Groundwater Transfer Review Summary Form

Transfer/PA # T- 13689

Application: T-13689

Applicant Name: Kittredge Properties LLC

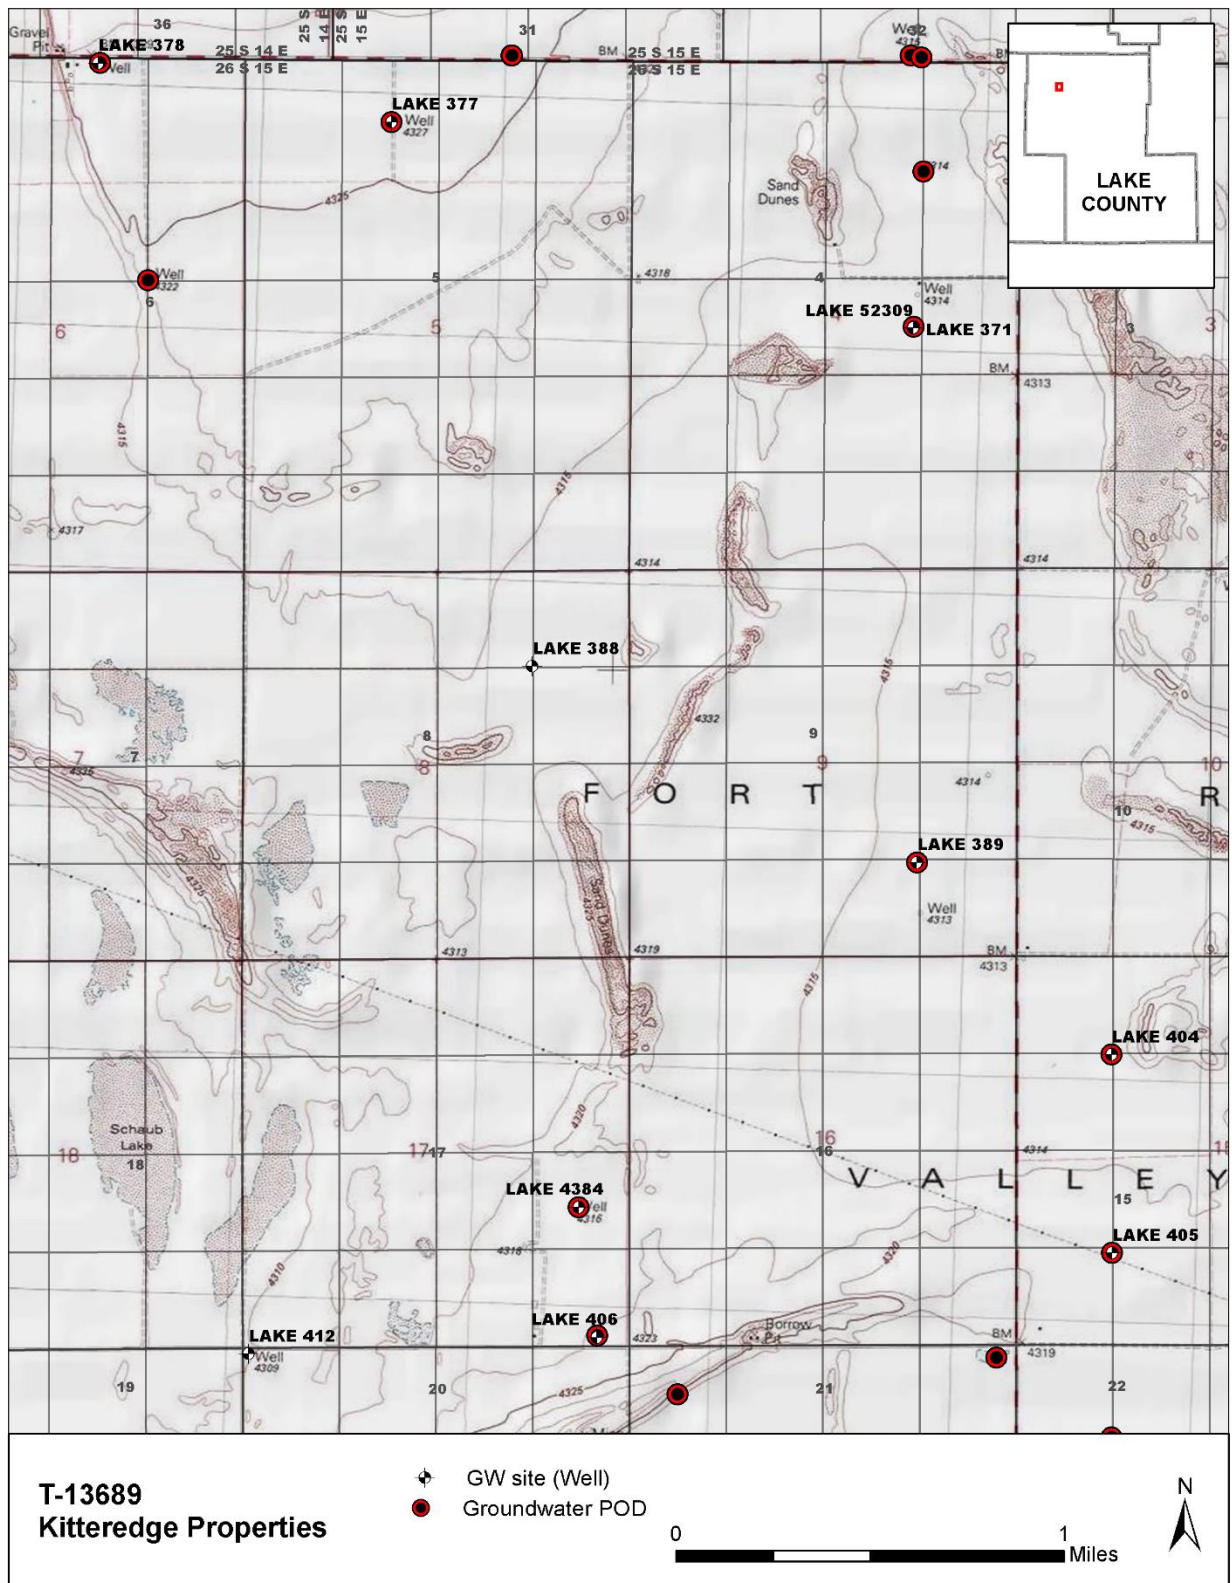
The long term impact on the groundwater system should be the same. That impact is to continue contributing to the ongoing annual Fort Rock Classified area groundwater level decline. See attached hydrograph depicting approximately 0.25 feet per year of annual decline.

**Theis Time-Drawdown Worksheet** v3.00

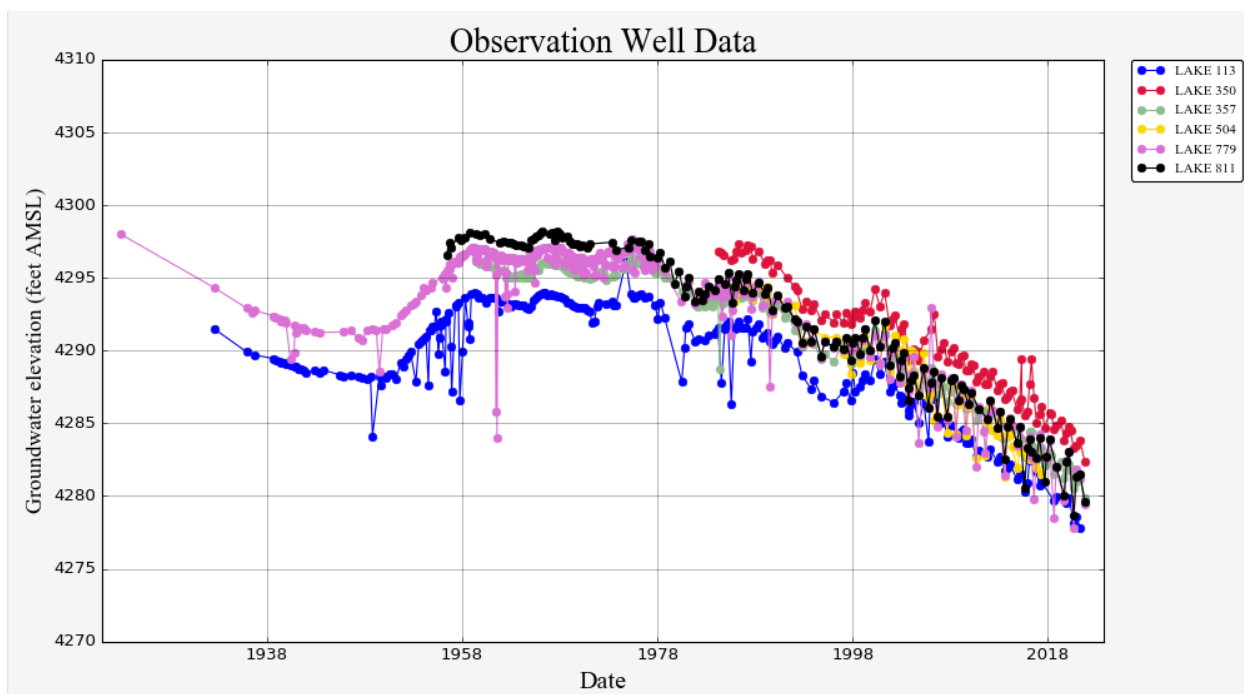
The nearest authorized well to the proposed APOA is POD 1 under certificate 53860 (LAKE 389) which is located ~5900 feet to the southeast. The potential increase in drawdown was calculated using the Theis equation (see attachments). The values used for the calculation are conservative and appropriate until better values become available. The calculation used an intermediate storage coefficient (0.001). The transmissivity used in the calculation (15,000 ft²/day) is from Morgan (1988) and McFarland and Ryals (1991). At the pro-rated pumping rate of the full duty over the full irrigation season (0.77 cfs), the results indicate a drawdown of <2 feet, which should be within the capacity of the nearby well.
